ADDENDUM 1

15 June, 2021

ITB AP 44-21

DTS Airport Hangar 8 Metal Roof Coating Replacement

Water Intrusion at the Ridge Cap Metal

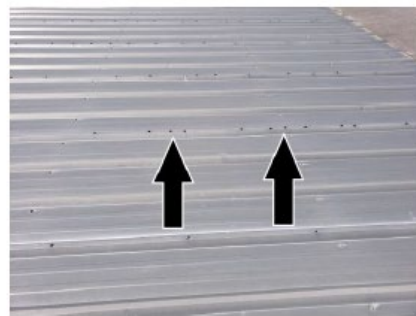
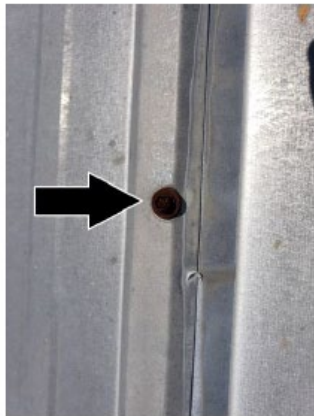
- a. A site visit was completed, however none of the attendees had release forms that were required to climb onto the roof. The attendees were allowed to photograph any portions of the building that they needed/wanted and the below exhibit is provided to show typical aspects of the current roof in lieu of any contractors being able to assess the day of the pre-bid meeting.

Rusted Fasteners

Answer: No need to remove to bare substrate. Intent is to go over or add to existing protection and seal any areas where moisture may be.
